EXPERIENCES FROM THE LNPP-P&DSA REVIEW

Lessons learned from RBMK safety studies

MANKAMO Tuomas (Avaplan Oy), MARTTILA Jouko, REPONEN Heikki. Experiences from the LNPP-P&DSA review. Lessons learned from RBMK safety studies. STUK-YTO-TR 168. Helsinki 2000. 43 pp.

Figure 2. Risk contributions (Hazard State A) for SNTV-3 by IE category.

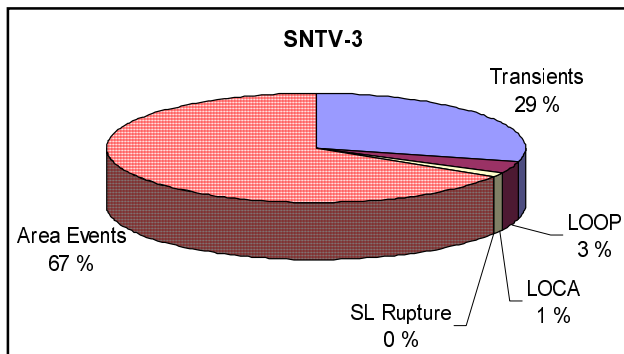
the small contribution of LOCAs in SNTV-3 is an unexpected result. The explanation can be an underestimation of the LOCA frequencies, see Section 5.6. Also the small contribution of LOOP, especially in SNTV-3, is somewhat unexpected and can be related to optimistic assessment of the LOOP frequency, see Section 5.3.

Figure 7. Schematic picture of service water connections. The parts, which are drawn by dashed lines belong to the reconstruction program, i.e. do not yet exist.

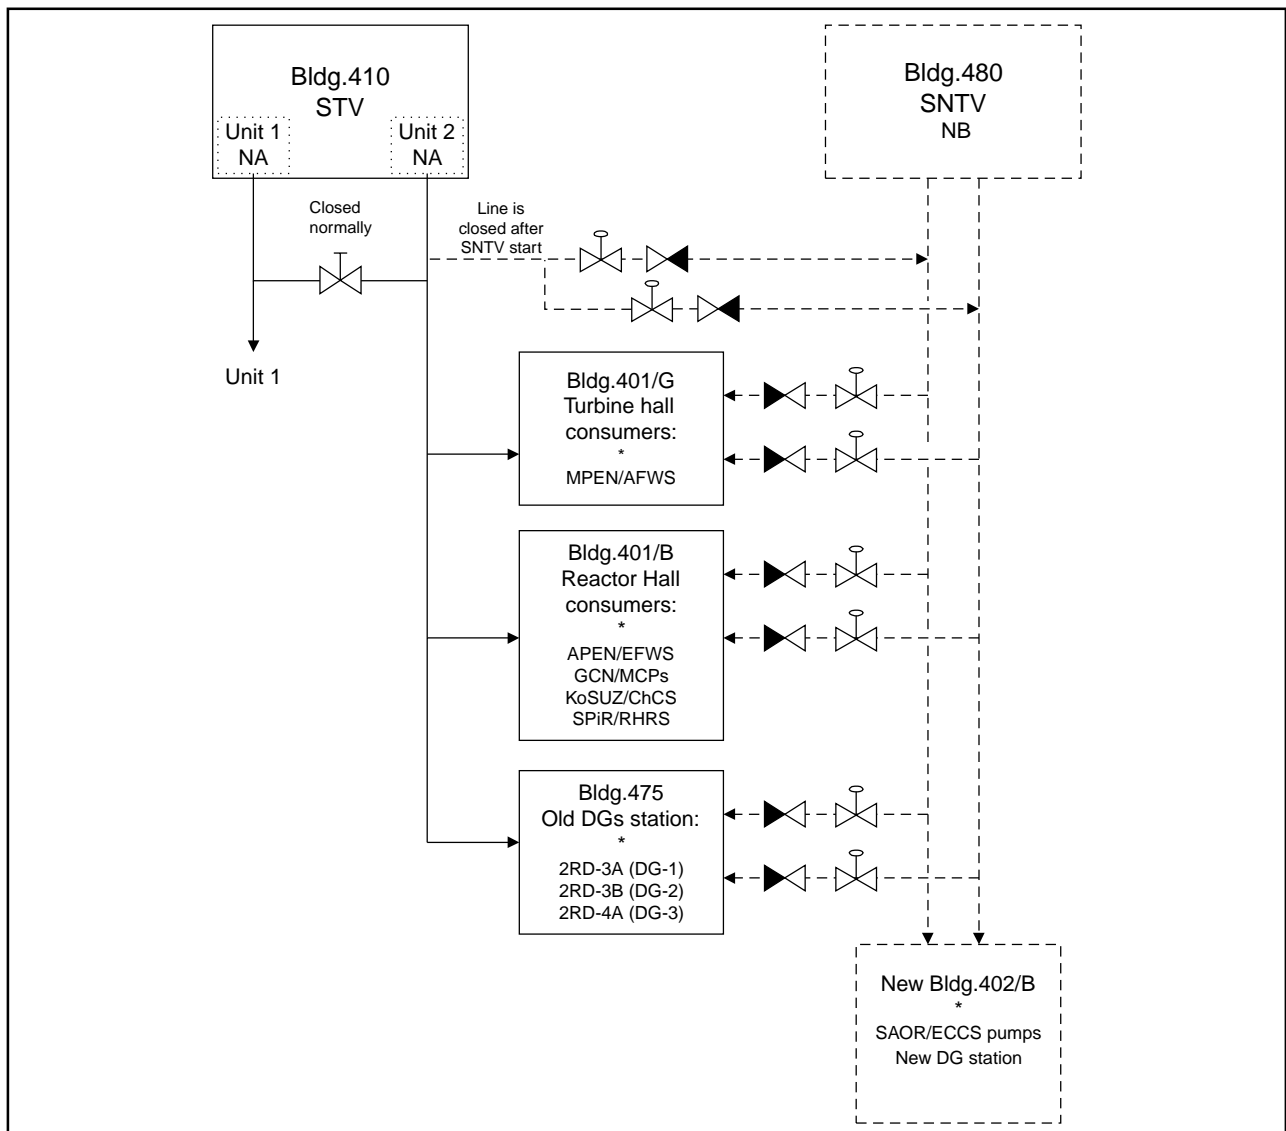
There exists cross-connecting option between Unit 1 and Unit 2 NA/NSWS through NA headers. In addition, the intermediate circuits for pump cooling and sealing functions can be cross-connected between Unit 1 and Unit 2 (these details are not covered in Fig. 7). The cross-connection is routinely used in repair situations when the unit is in shutdown state and now there exist instructions for the manual operations also for power operating condition.

Modeling of ICCs and many cross-connection options between the ICCs of Unit 2 and 1 have not been reviewed. This topic should be addressed in the continuation.

Figure 8. Principal causal sequences leading to total loss of service water at LNPP Unit 2 in the current state (SNTV-3 model).

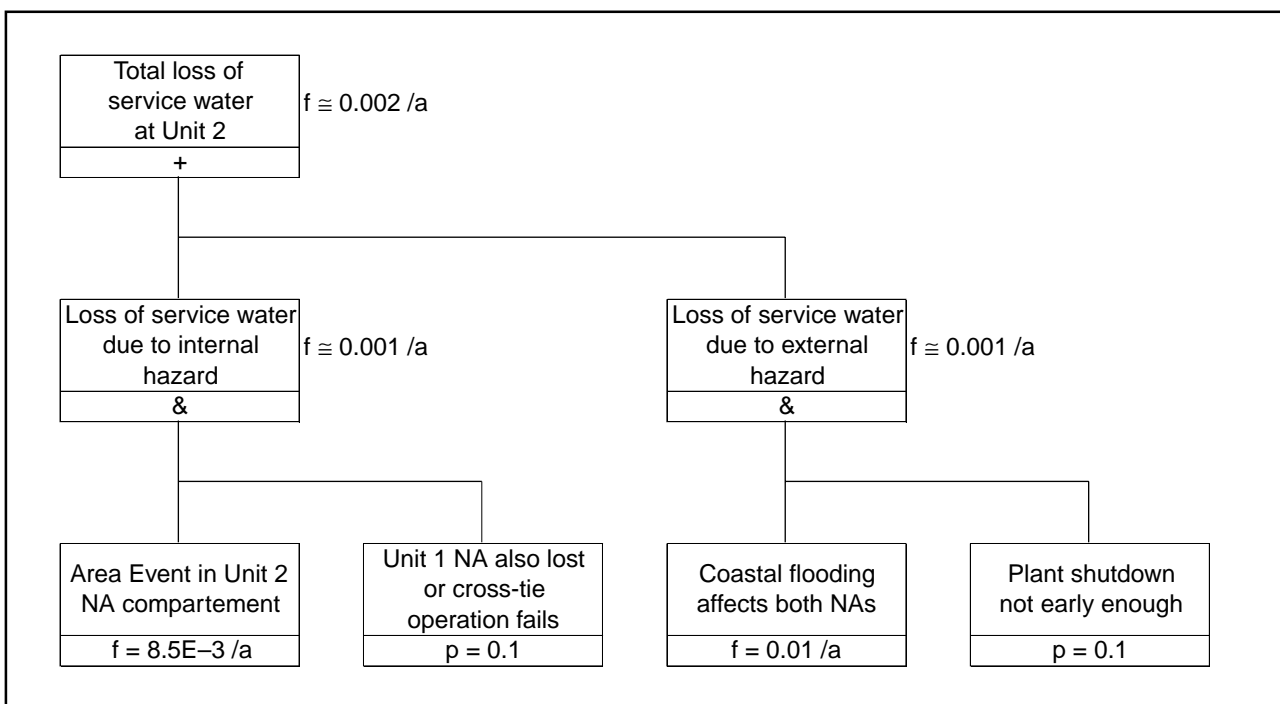
Initially the AE(NA) was effectively handled as a common cause event for both Unit 1 and Unit 2 without credit to the cross-tie possibility. This assumption was defended on the basis of the risk of external flood. In principle that is a relevant argument even though inconsistent with the scope of P&DSA Phase 2. The prominent cause to external flood is high sea water level, which however is likely not to be a sudden event but can be foreseen by some time window. This allows preventive measures e.g. shutting down the plant in advance to increase possibility to manage residual heat removal in case the sea water pumping station will be lost.

lead to total loss of service water for Unit 2. Due to its high importance, the internal and external hazards to NA should be analyzed separately from the index analysis method, which can be used to cover the bulk of the plant rooms. For a consistent treatment the initiating events should be divided into:

The different subcategories should then be modeled accordingly. In addition to the analysis of evidently important coastal flooding risk also other sea water and weather hazards should be considered. Regarding the internal hazards the possibility of losing both NA/NSWSs in an extensive fire or internal flooding should be considered. Especially, the fire affecting the power and signal cables should be analyzed.

Figure 10. LOCA size classes in LNPP-PSA compared to the standard definition of BWRs and PWRs. D is inner diameter of pipe [mm].

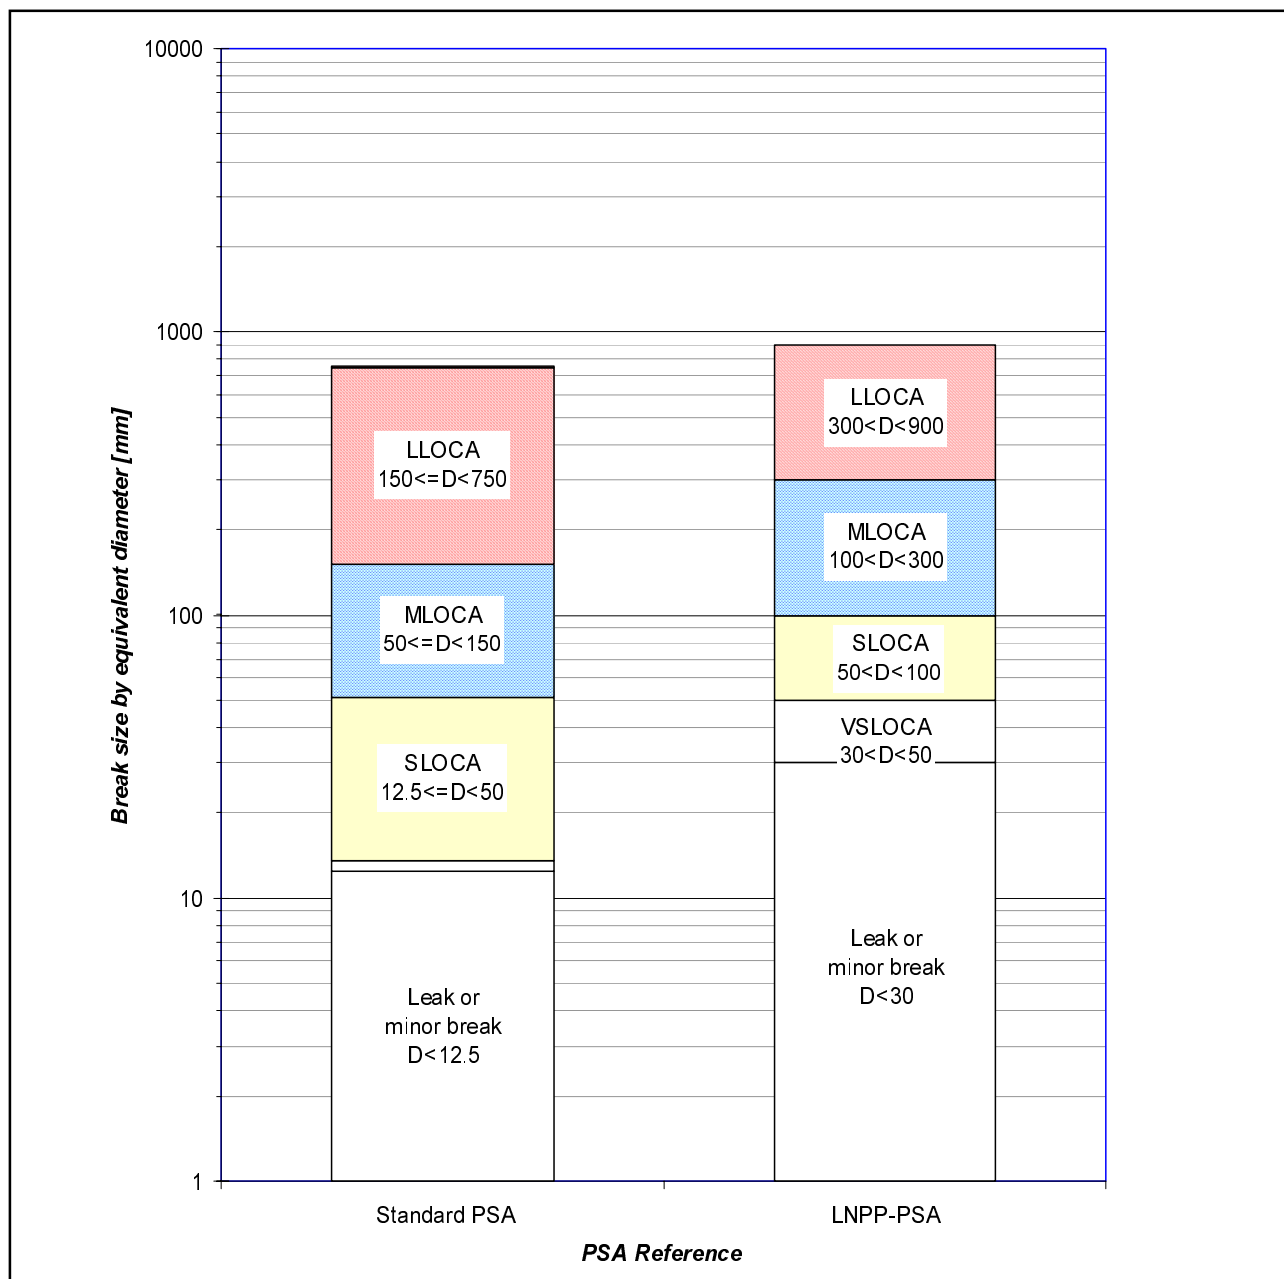
SLOCA range is relatively narrow. The boundary between SLOCA and VSLOCA is not orderly explained in LPR010. Substantiation by termohydraulic analyses does not show up. VSLOCA is handled as TM (manual shutdown), which is neither clearly substantiated. It should be noticed that a break of diameter of 50 mm can lead to an outflow of 70 kg/s (250 m³/h), which corresponds to the capacity of one APEN or MPEN pump. In comparison, the capacity of one small make-up (hydro sealing) pump NGU is 30 kg/s (100 m³/h): thus all three NGU pumps would be needed to compensate maximal VSLOCA.
